PROJECT NUMBER: SP2020-028  
PROJECT NAME: Site Plan for Courtin Dental  
SITE ADDRESS/LOCATIONS: 710 W RALPH HALL PKWY

CASE CAPTION: Discuss and consider a request by Darrel Kotzur, PE of KSA Engineers on behalf of the owner Mary Courtin of Courtin Dental for the approval of a Site Plan for a daycare facility and a medial office on a 1.743-acre tract of land identified as a portion of Lot 9, Block A, Flagstone Corners Addition, City of Rockwall, Rockwall County, Texas, zoned Planned Development District 54 (PD-54) for Commercial (C) District land uses, situated at the southeast corner of the intersection of E. Ralph Hall Parkway and Mims Road, and take any action necessary.

10/22/2020: SP2020-028; Site Plan for Courtin Dental - Flagstone Corners Addition  
Please address the following comments (M= Mandatory Comments; I = Informational Comments)

SEAL: TBPE Firm Registration No. F-1356  
 SHEET NO. **C1.0**

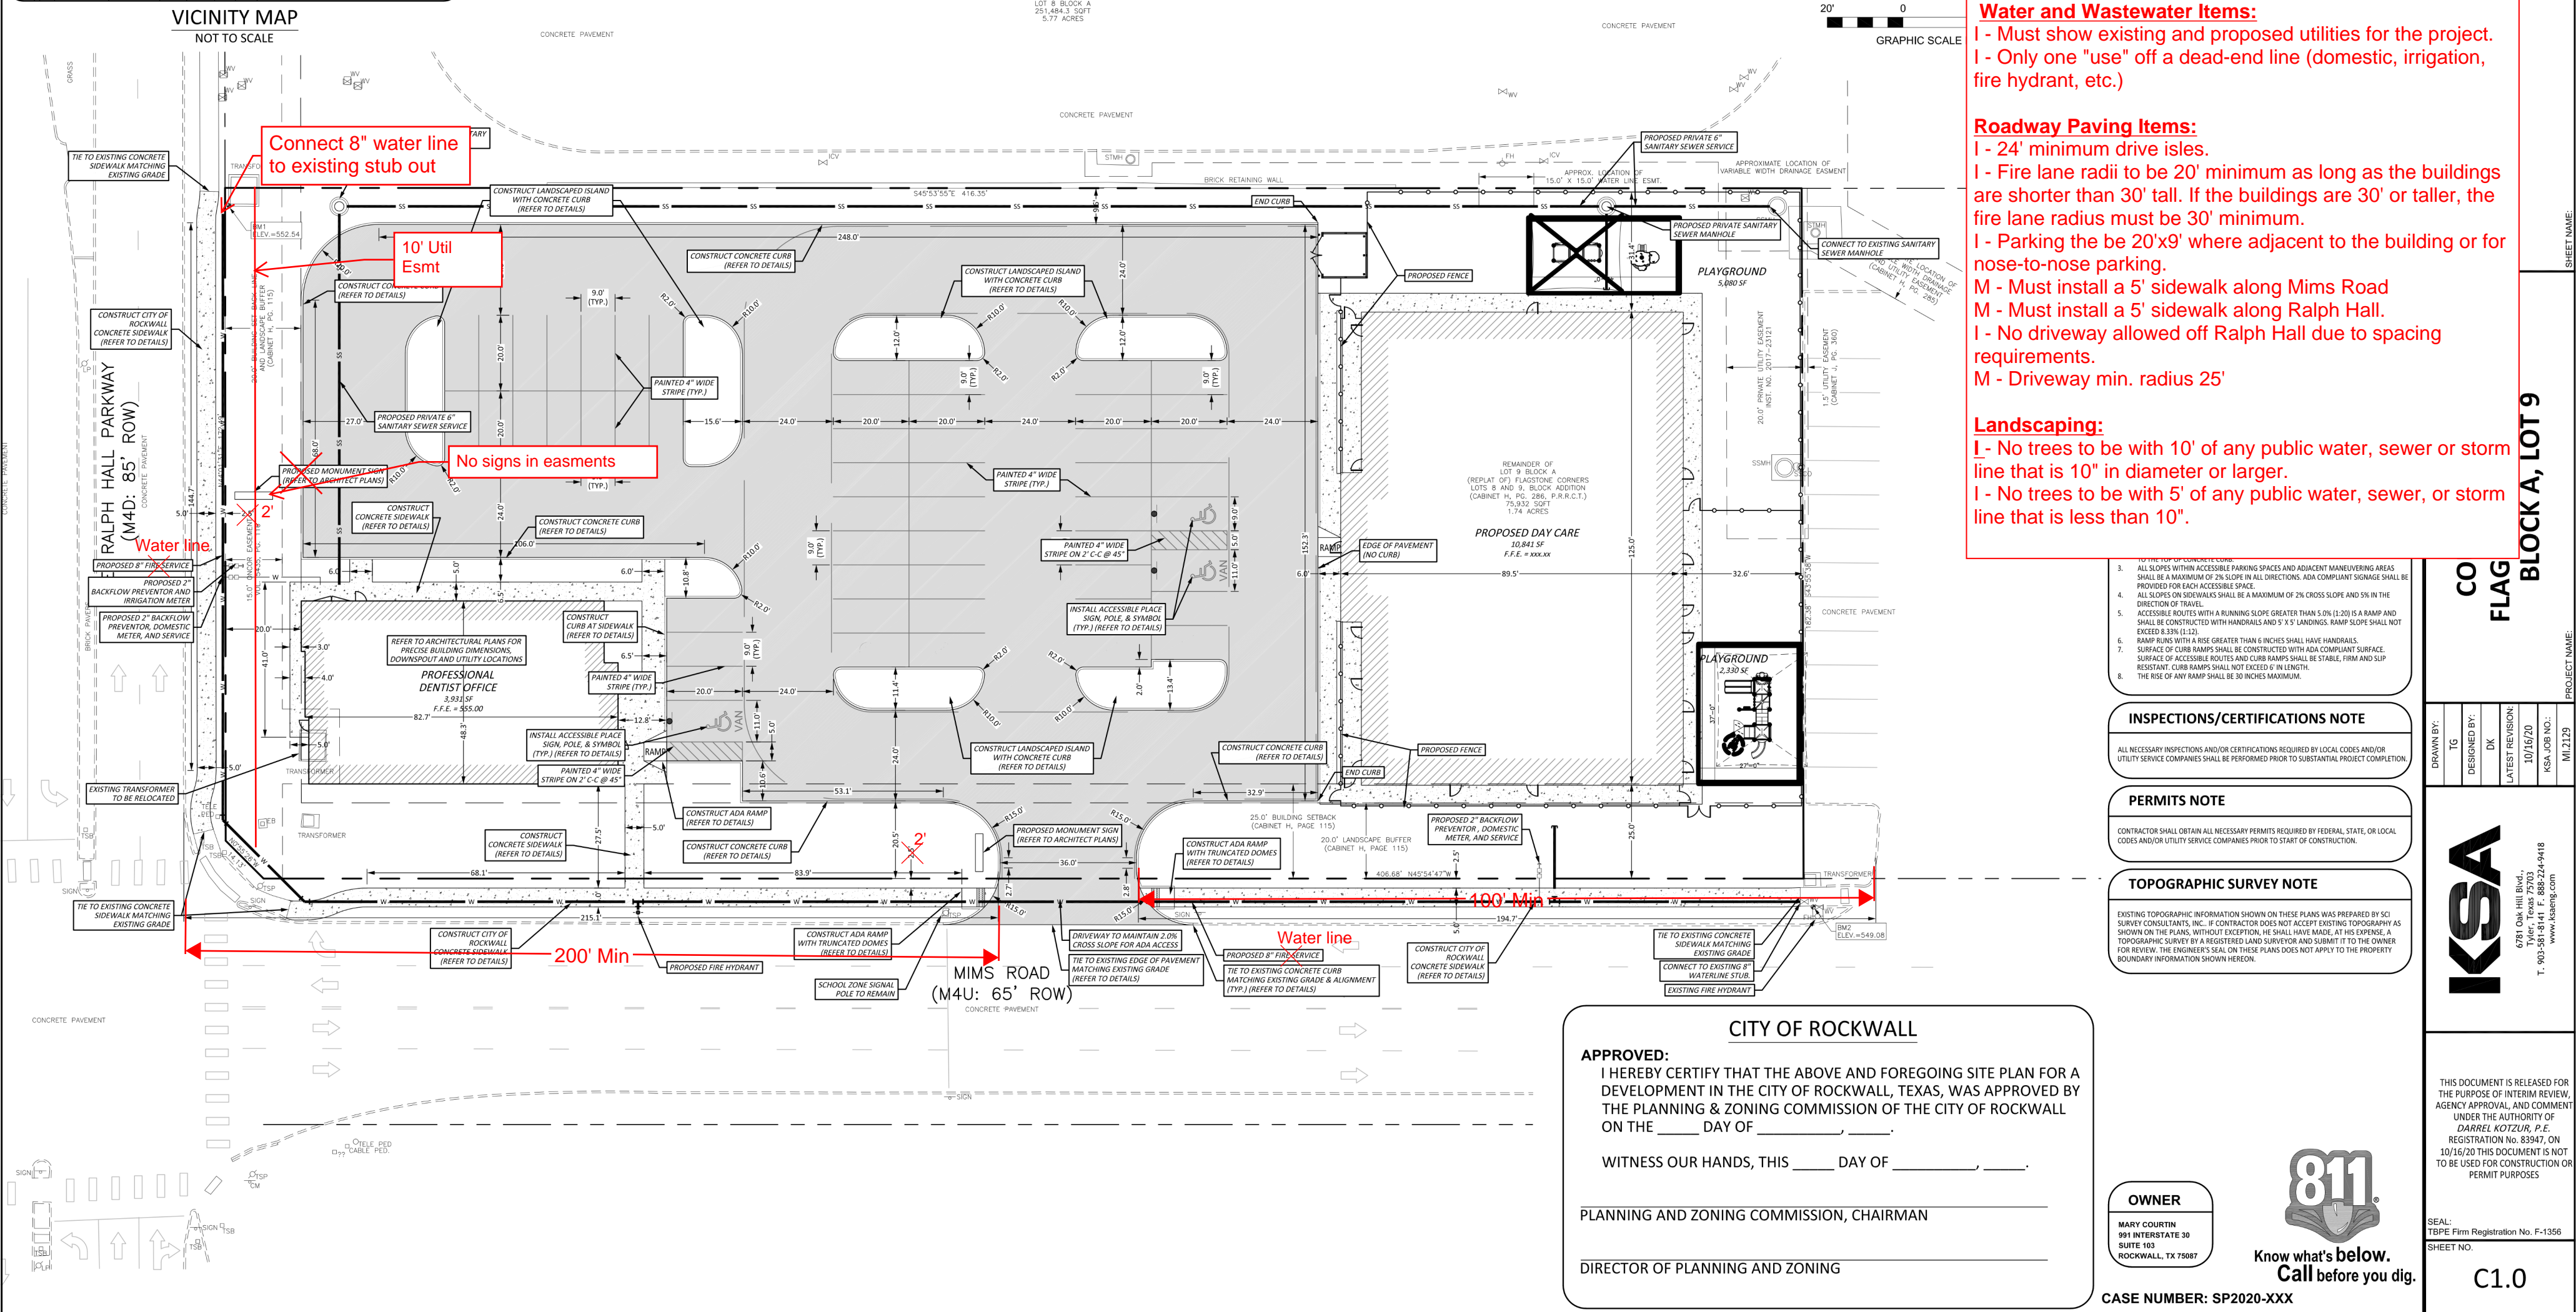
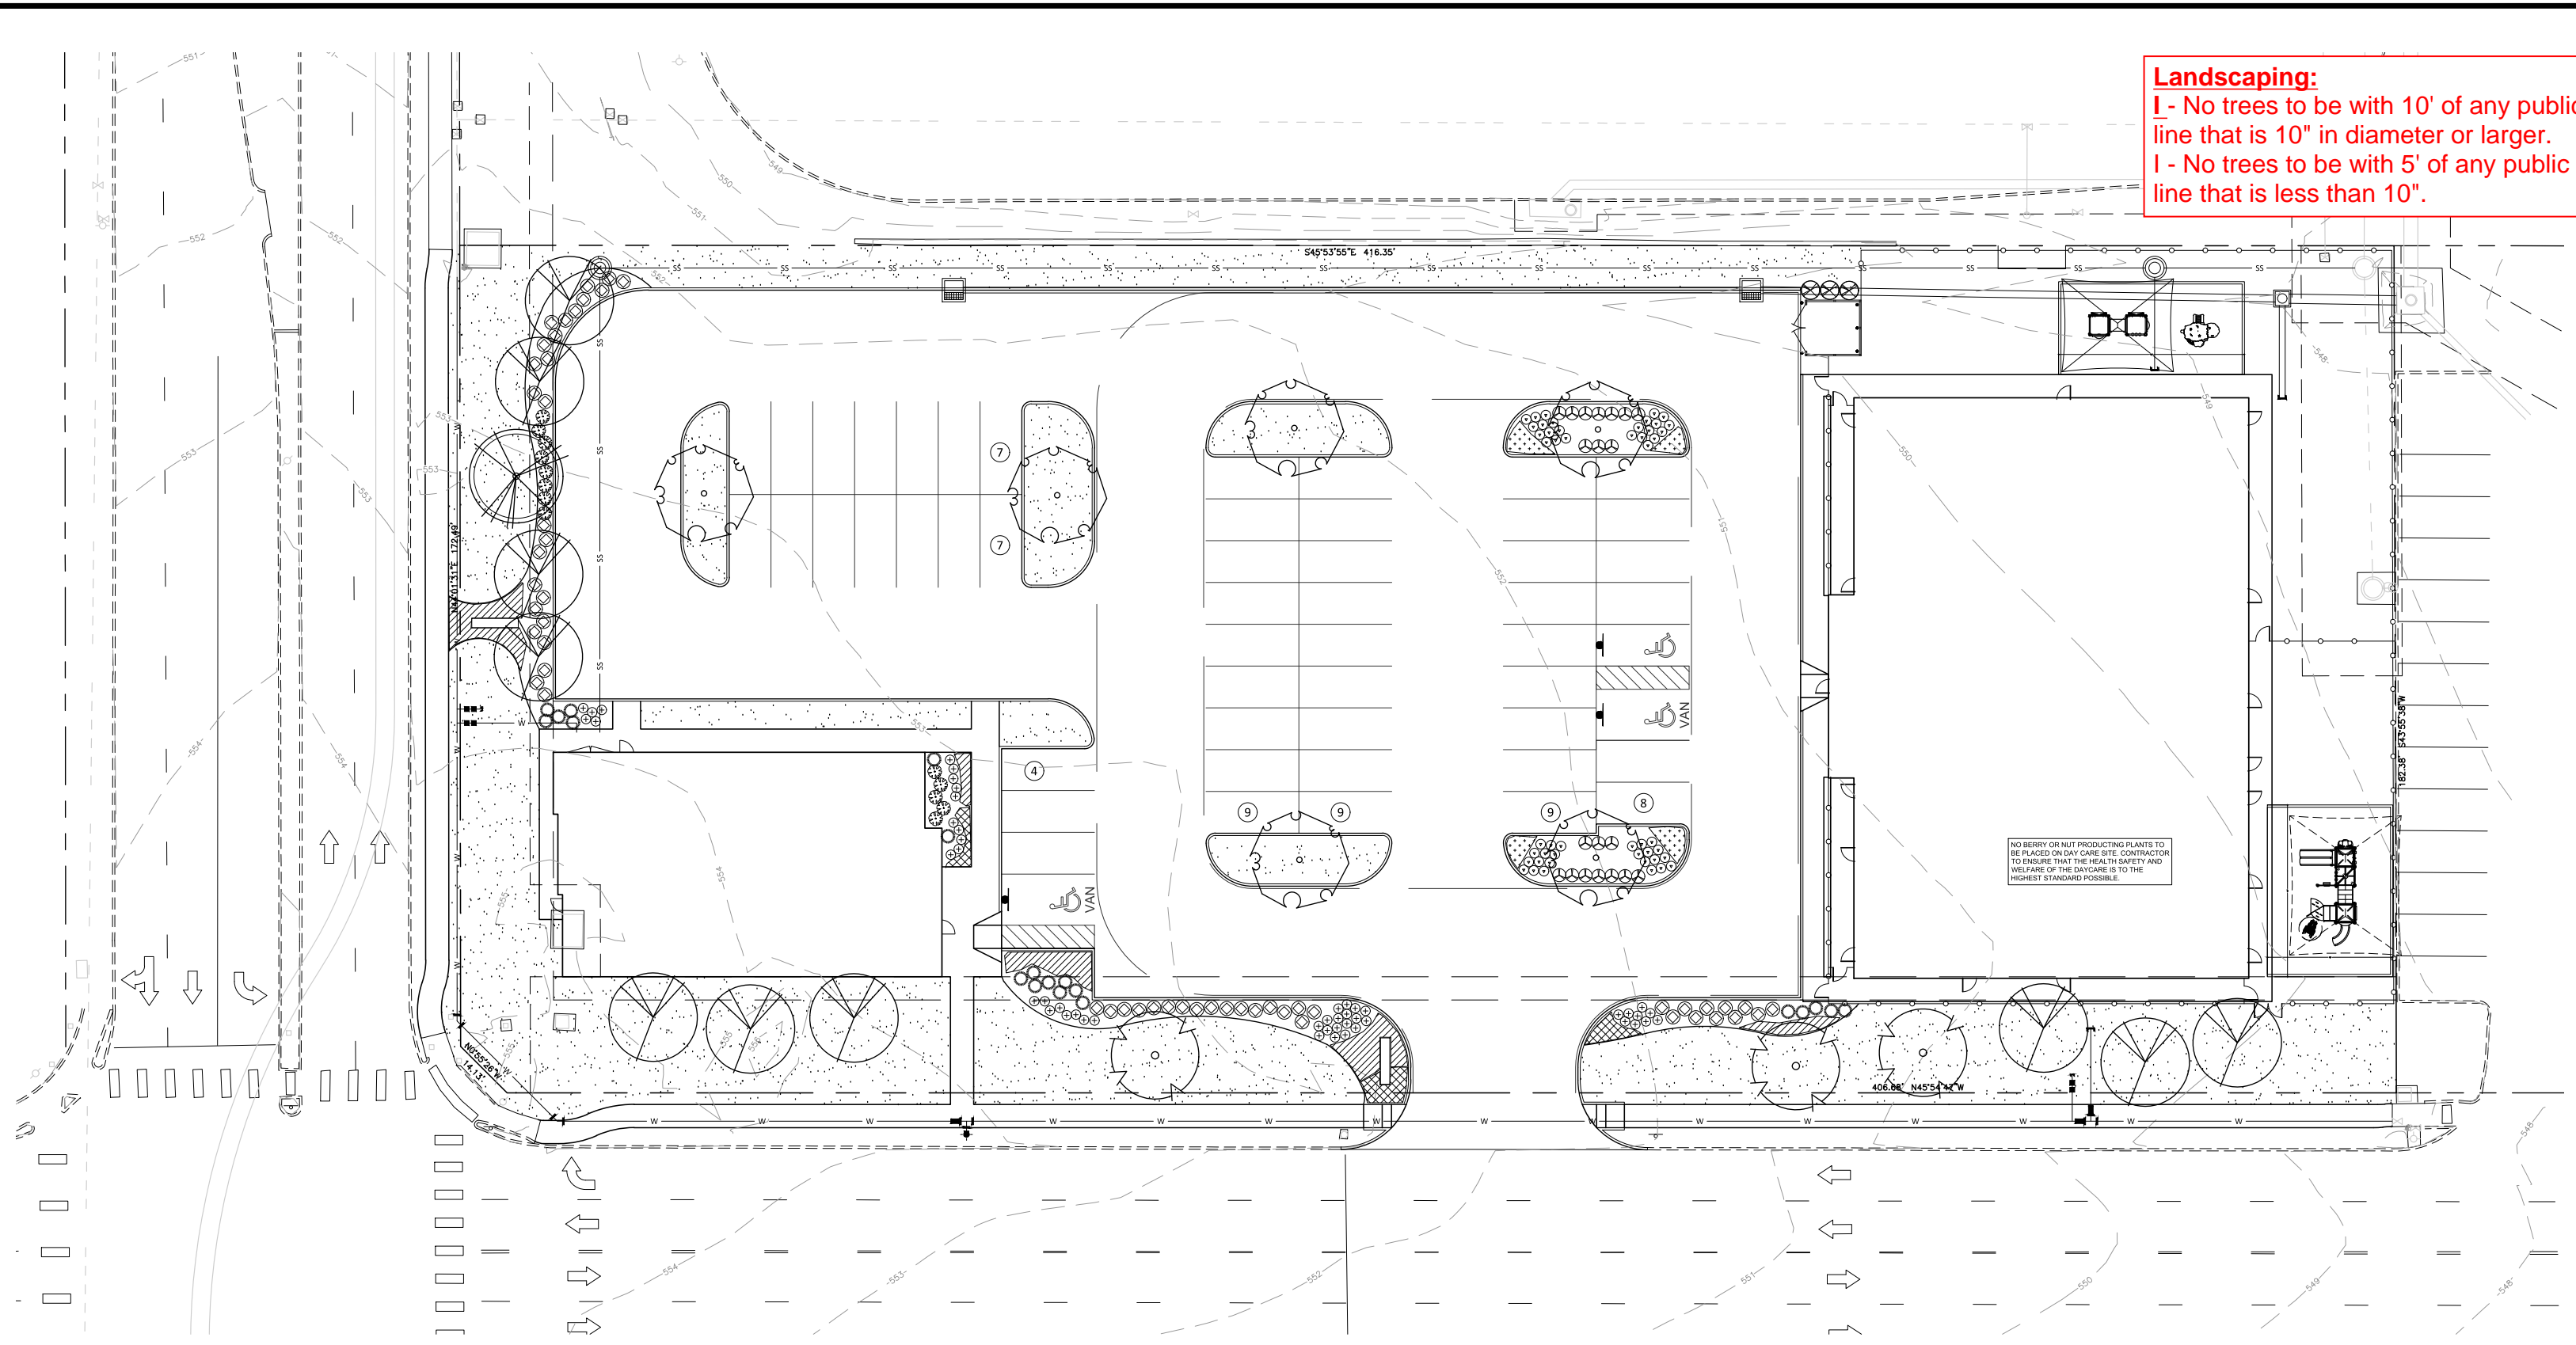
M.8 Site Plan. Please make the following clarifications on the site plan to ensure staff can properly review this project and convey all of the required elements to the City's boards and commissions (§01.02, Art. 11, UDC):

- 1) In the Site Plan Information Legend, remove "current – undeveloped". (§03.04.A, Art. 11, UDC)
  - 2) Provide a label for all Firelane to indicate "24-ft Firelane, Public Access, Drainage, & Utility Easement", as appropriate for existing and proposed. (§03.04.B, Art. 11, UDC)

- 6) Identify visibility triangles on all lots for all driveway intersections and public streets. (§01.08, Art. 05, UDC)
- 7) Provide note indicating irrigation will meet requirements of UDC on Sheet No. L1.1. (§05.04, Art. 08, UDC)

- 8) Provide a label for the adjacent street names (i.e. Mims Road & Ralph Hall Parkway).
